Agenda
Village of Arlington Heights
Design Commission
Community Room, 3rd Floor

Arlington Heights Village Hall
33 S. Arlington Heights Road
Arlington Heights, IL 60005
September 20, 2016
6:30 PM

**MINUTES OF
THE VILLAGE OF ARLINGTON HEIGHTS
DESIGN COMMISSION MEETING
HELD AT THE ARLINGTON HEIGHTS MUNICIPAL BUILDING
33 S. ARLINGTON HEIGHTS RD.
AUGUST 23, 2016**

FRONT ELEVATION
REAR ELEVATION

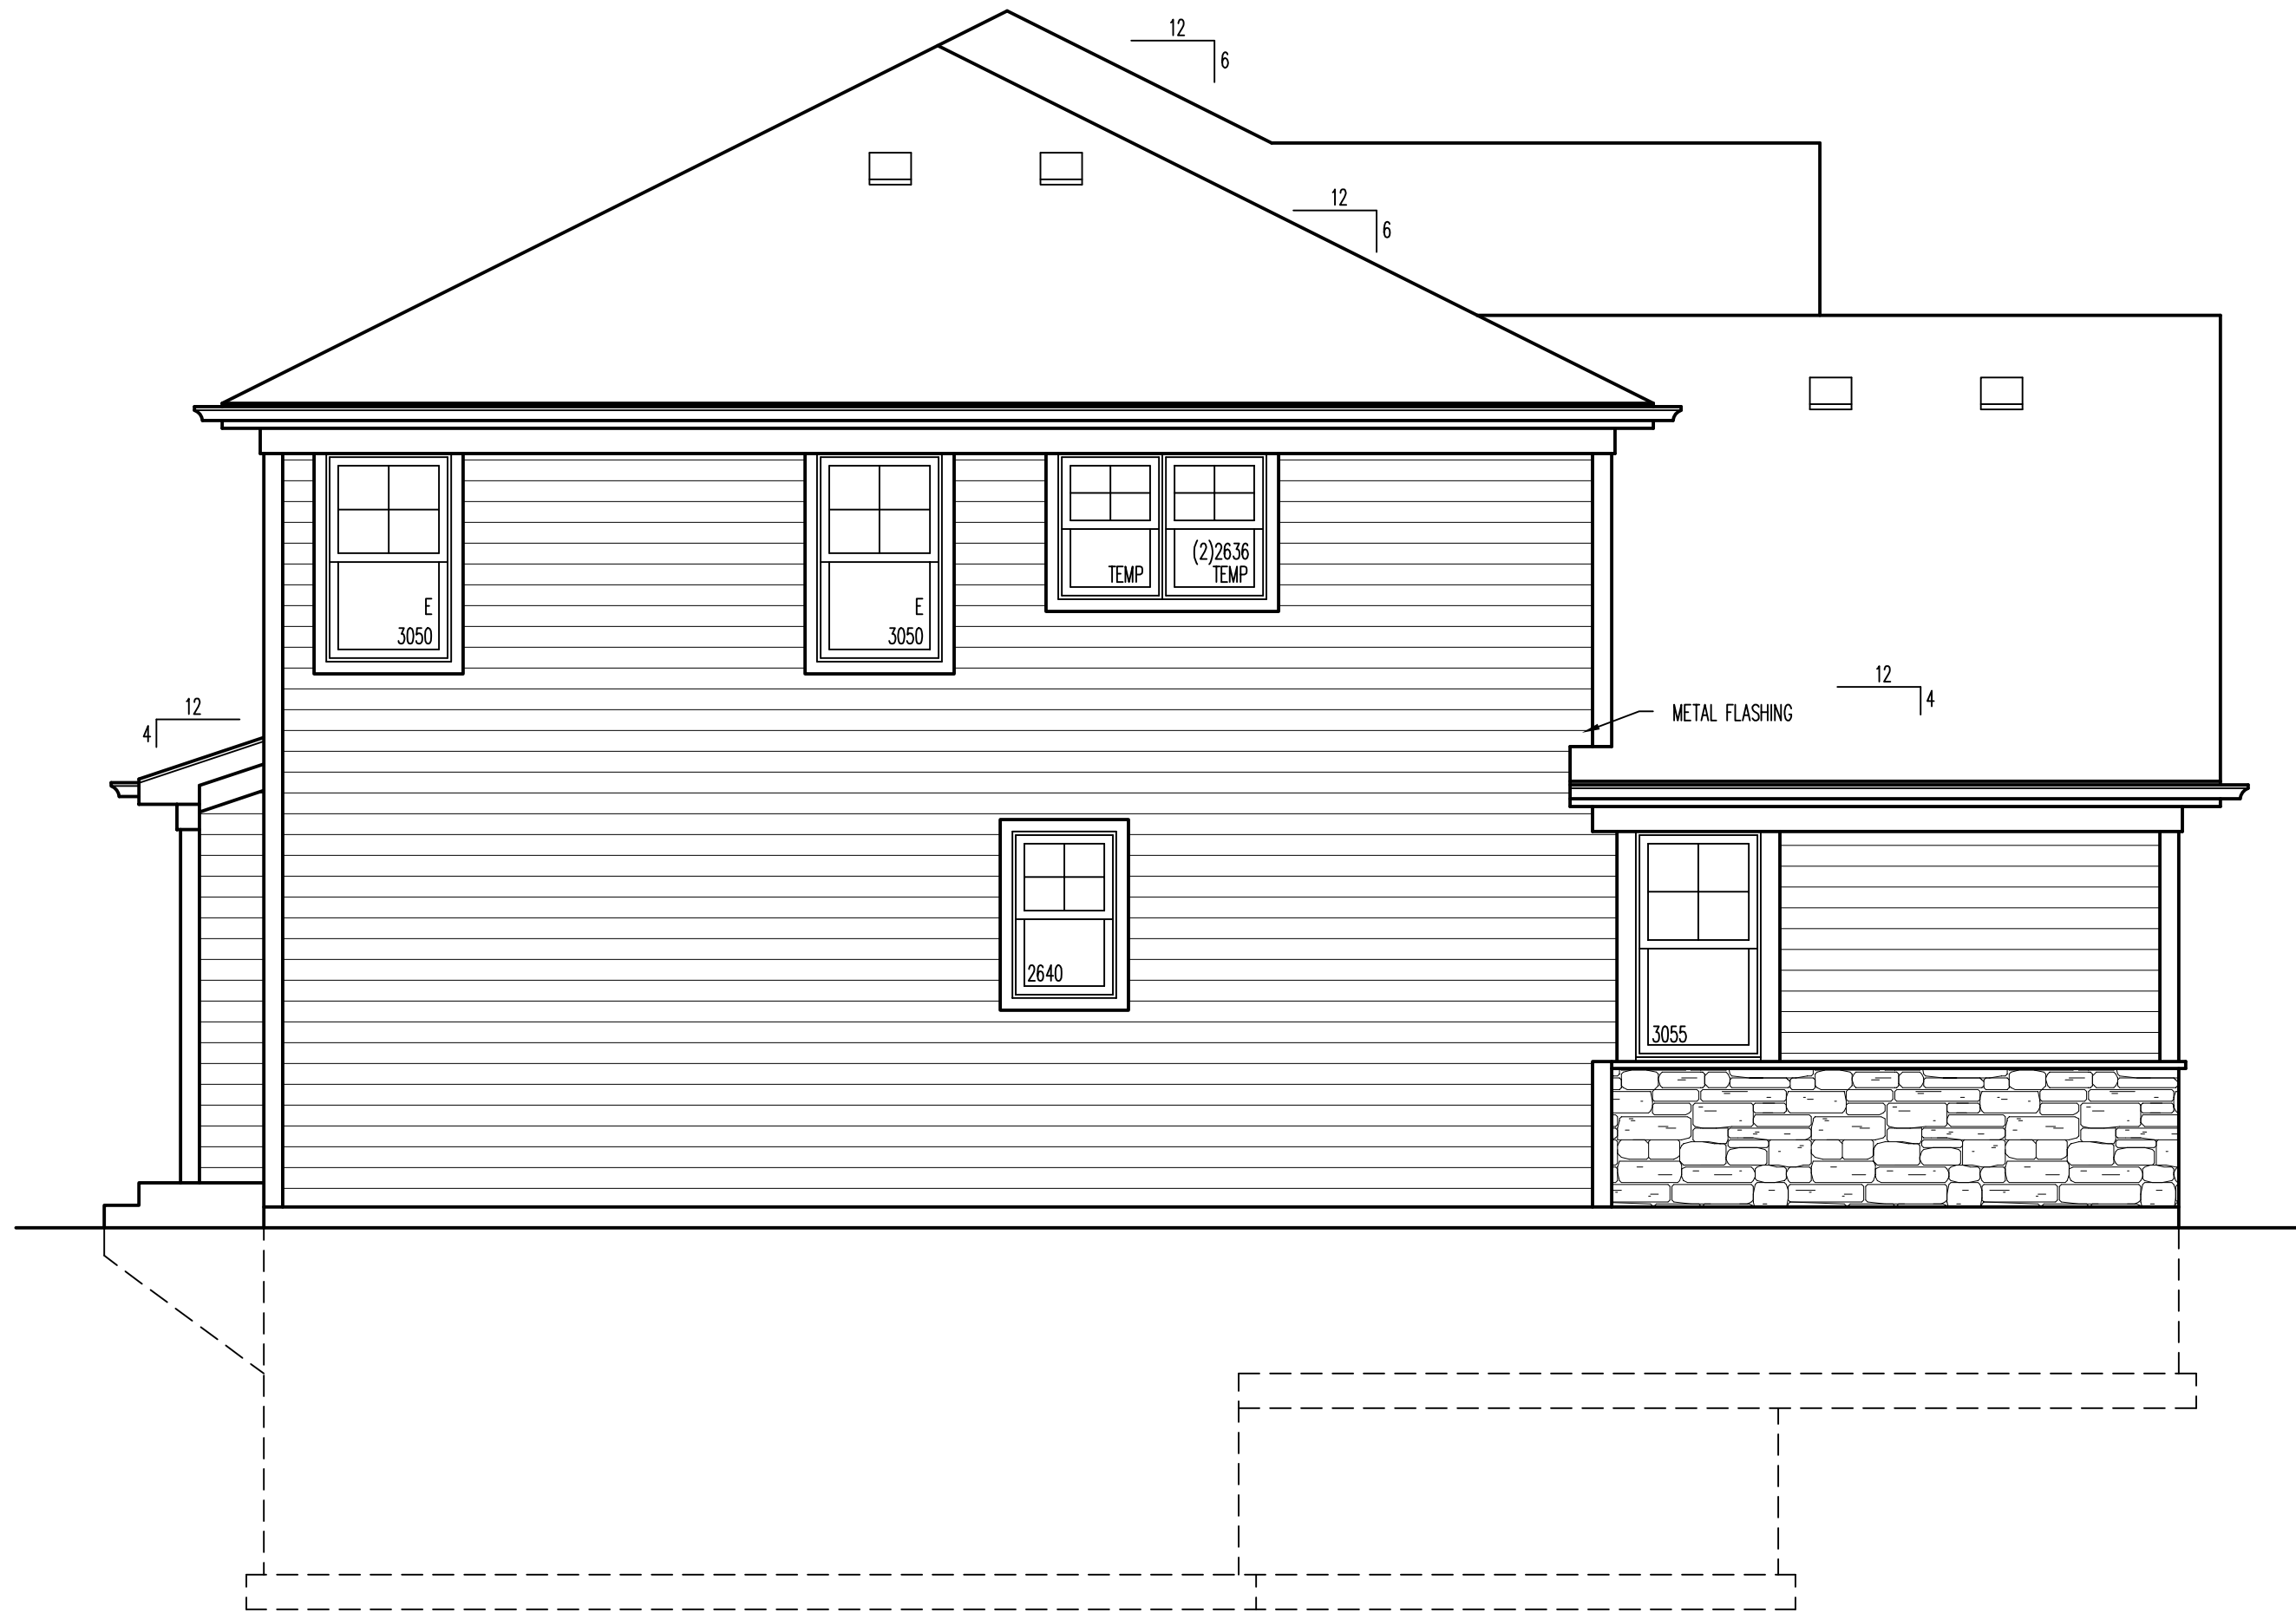
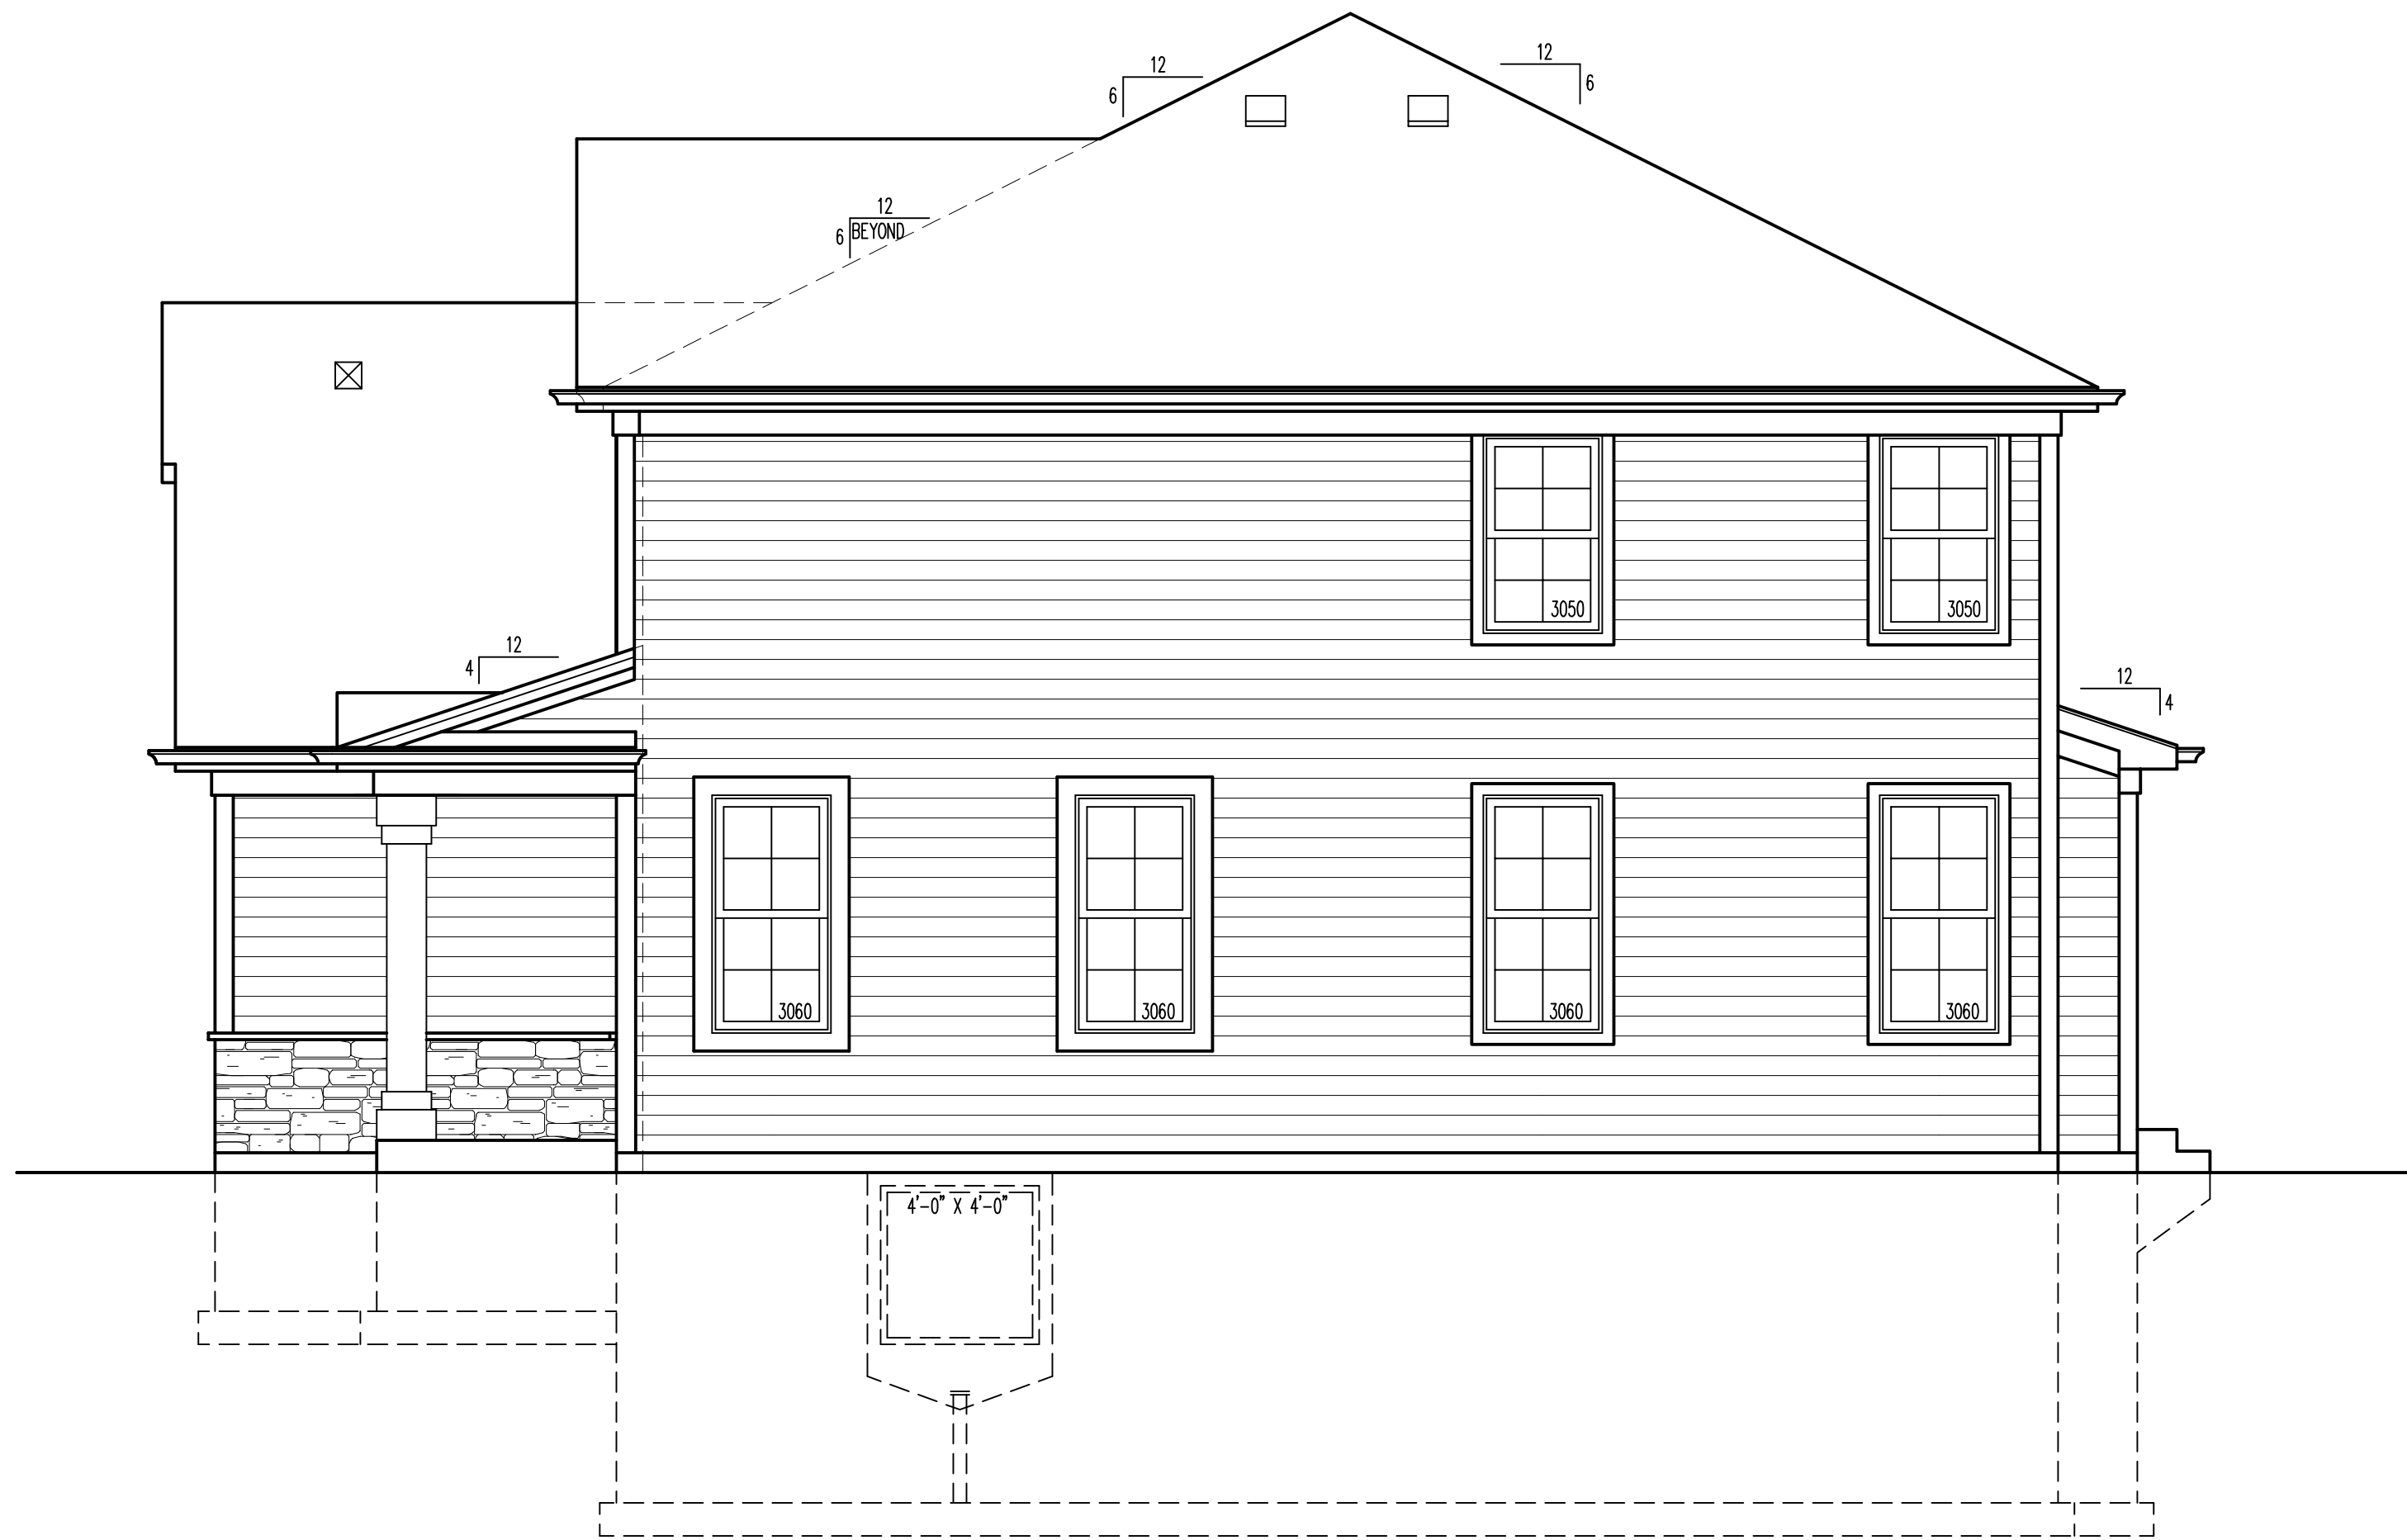
1. The size and scale of the proposed garage is a concern as it relates to the context of the smaller homes in the neighborhood. It is recommended that the scale of the garage be reduced by changing the roof form or reducing the roof slope. This same design (with modifications) was previously approved by the Design Commission in 2014 down the street at 409 W. Maude Ave, and at that time, Staff expressed concern about the size and scale of the garage. It was suggested to provide two separate 8 foot wide garage doors and jog the front wall of the garage to break up the mass of the large flat garage gable, but the project was approved as submitted.

2. The house directly across the street, which was approved in 2006, has the same basic overall symmetrical design with a center entry and full front porch. From the standpoint of monotony, it would be better if the massing of the proposed design was modified to create a different appearance, possibly asymmetrical.

A last suggestion would be to add a 4' x 8' covered portico over the back patio door to break up the scale of the large rear wall.

2. Revise the massing on the front of the house to be different than the house across the street, possibly asymmetrical, to be approved by Staff.
3. Add a 4' x 8' covered portico over the back patio door.
